Burlington Development Review Board

Development Review Board

ZSP-25-3; 453 Pine Street (E-LM, Ward 5) Derrick Davis / Alain Youkel

TO: Development Review Board
FROM: Scott Gustin
DATE: May 20, 2025
RE: ZP-25-192; 475 Lake Street

FFF PROJECT NO: 2411	
ORIGIN DATE: 04/30/2025	SCALE: As indicated
DRAWN BY: ZIG	CHECKED BY: PMB
ISSUE LOG: PROGRESS DWG 05/05/2025	
SHEET CONTENTS: Site Plan	
SHEET NO: C201

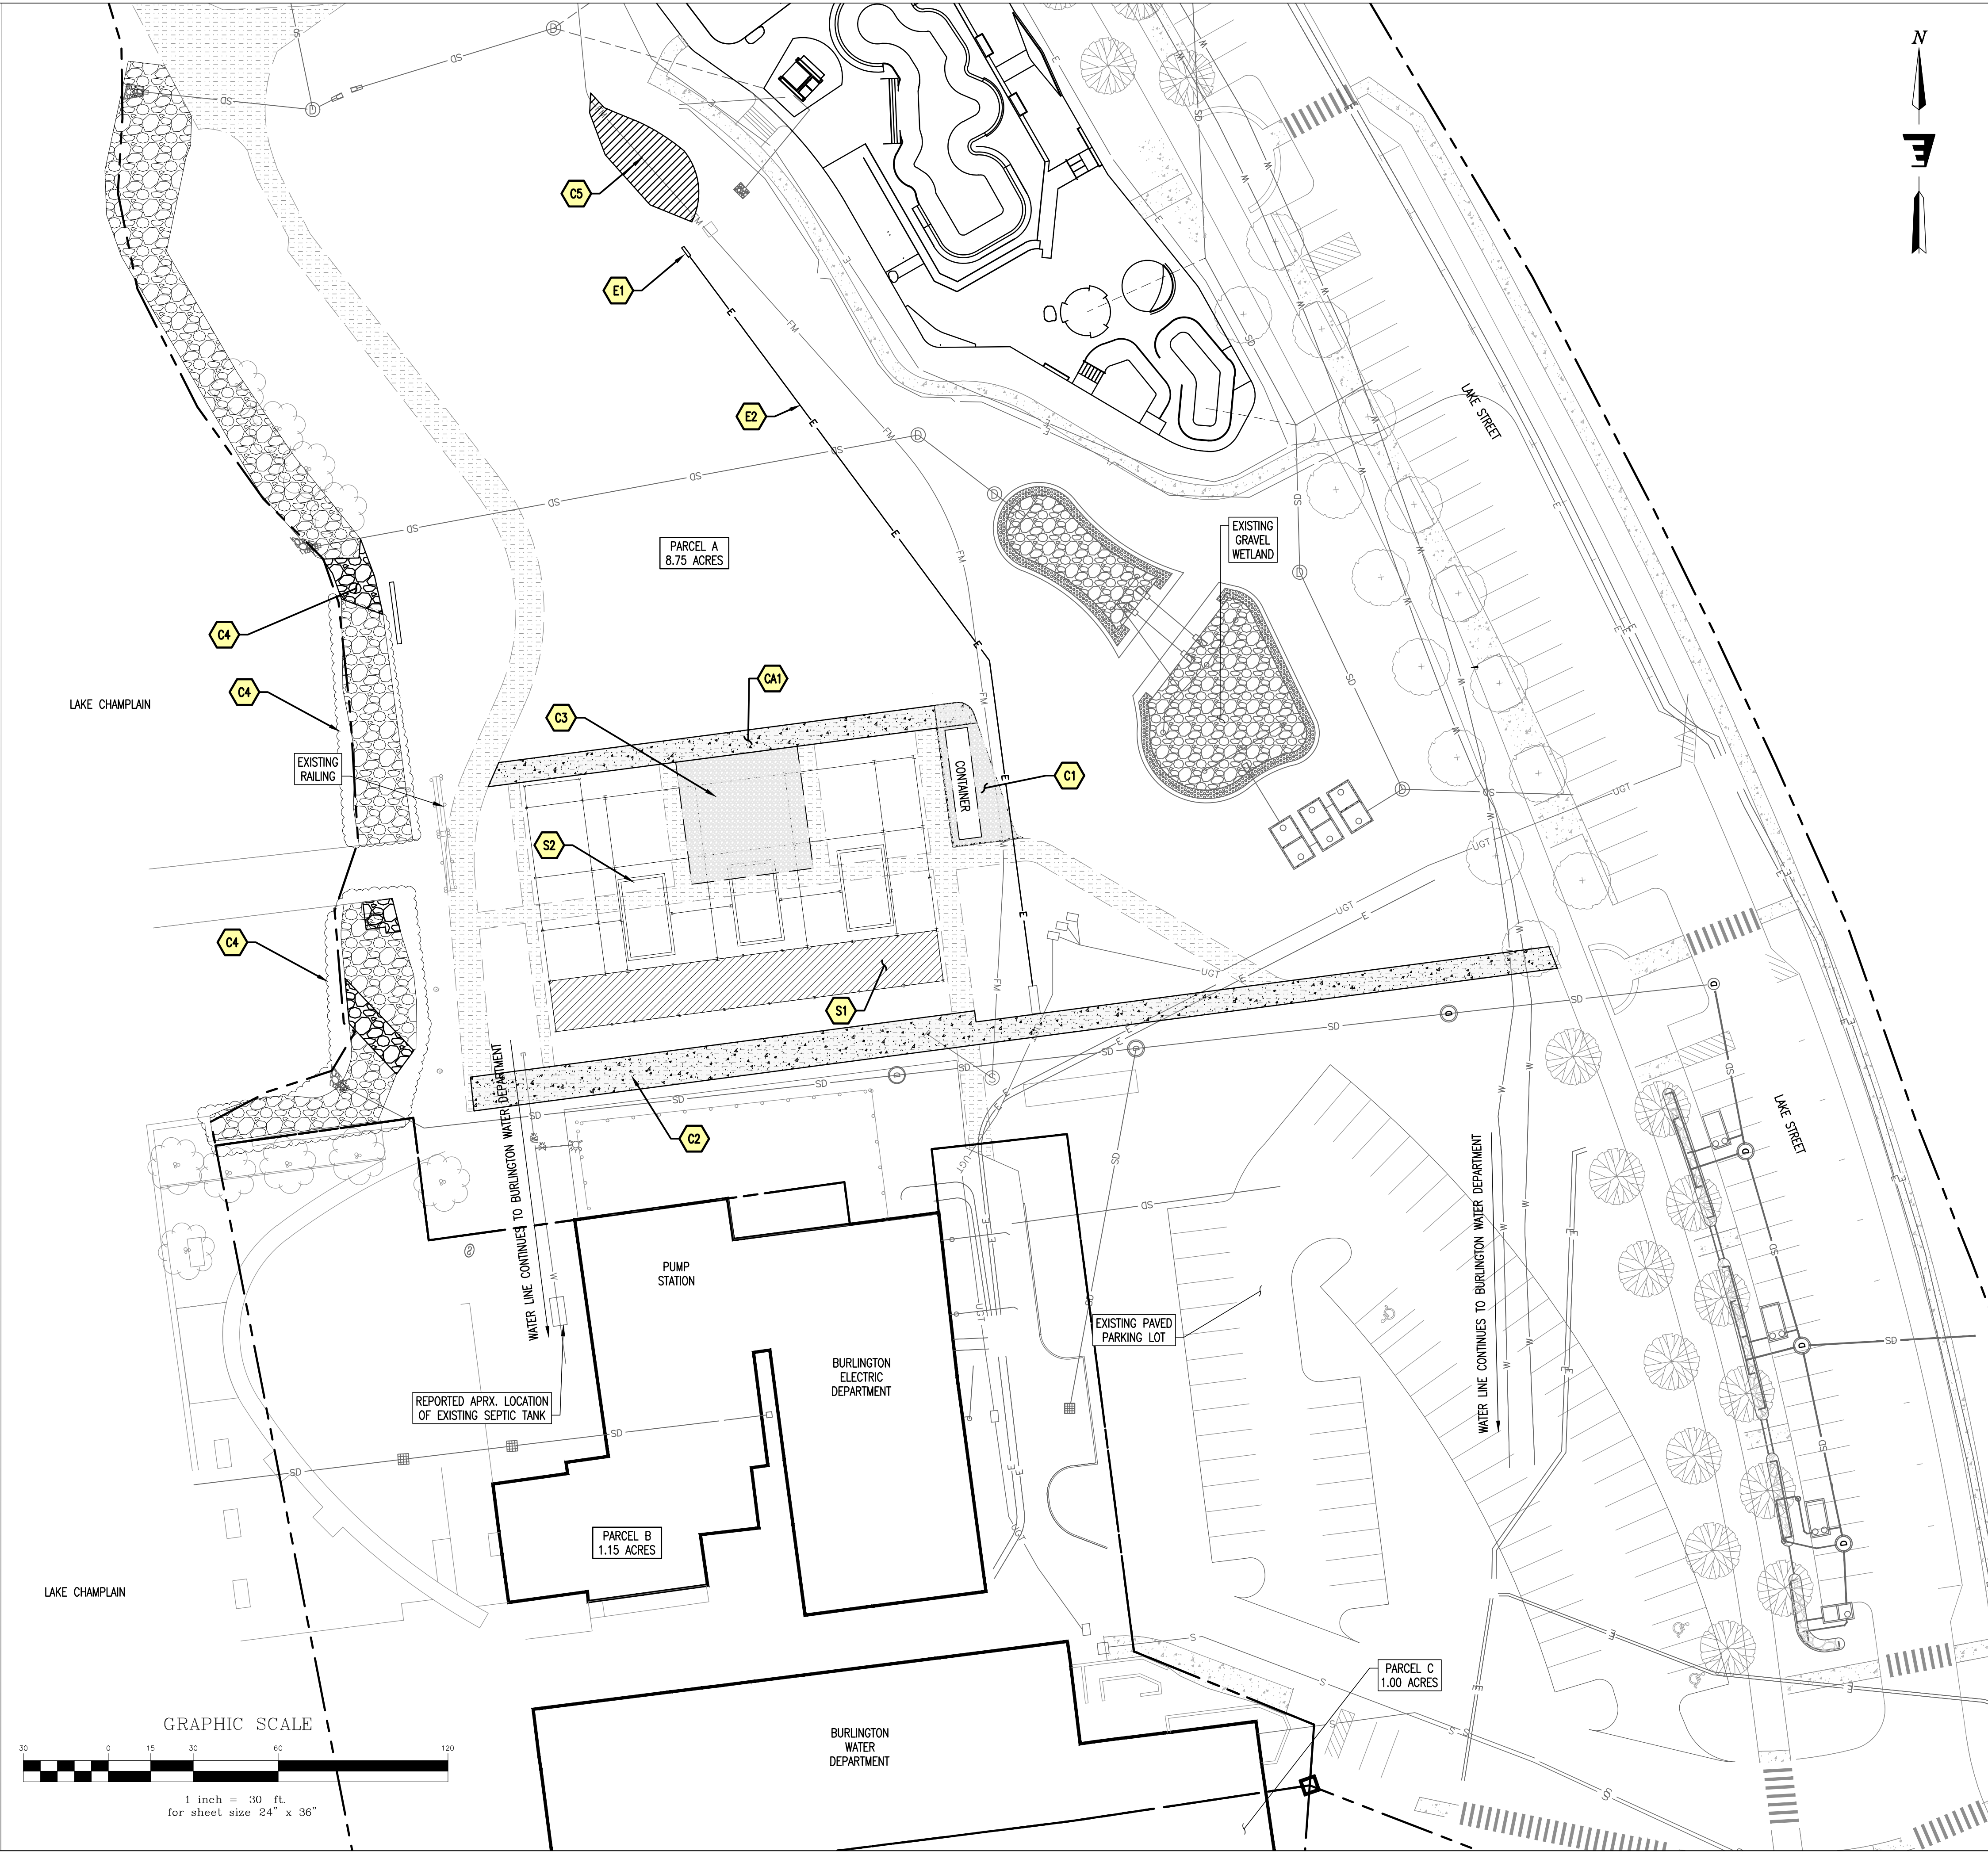
There is no lot coverage limit in the DW-PT zone. Existing lot coverage is 47.09% and will increase modestly as a result of the proposed work. Resultant lot coverage is not evident in the project plans and must be specified.

1. **Prior to release of the zoning permit**, revised site plans containing existing and proposed lot coverage information shall be provided, subject to staff review and approval.

Site Plan with Proposed New Property Line scale: 1" = 60'

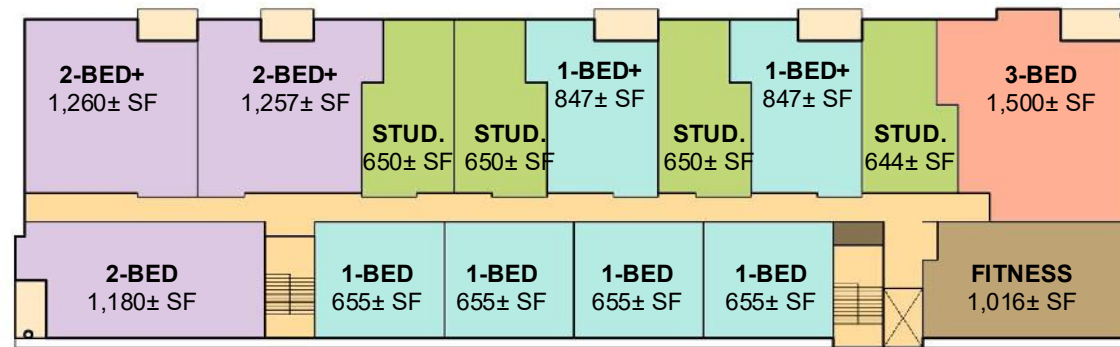
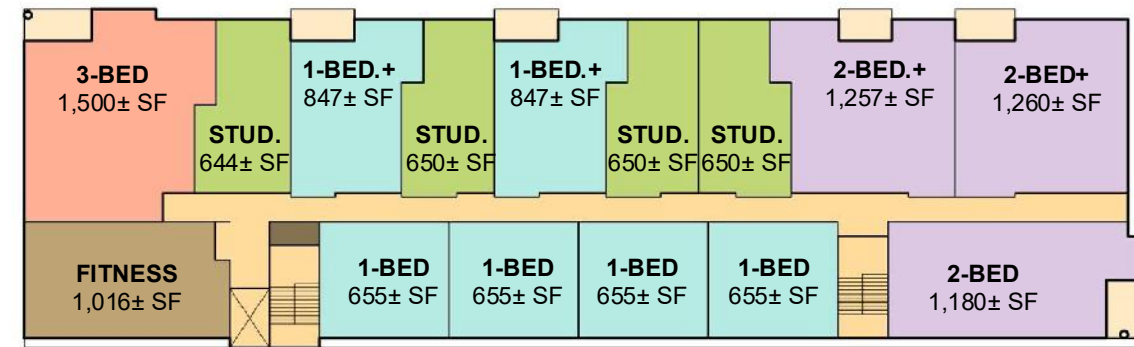
Proposed lot coverage comes to 55.8% and is well under the 80% limit. At least 25% of the pervious area on the lot needs to utilize one or more of three green stormwater infrastructure techniques identified in footnote 6 above. The sketch plans lack applicable details as to this item. A pending zoning amendment may affect this criterion prior to zoning permit application.
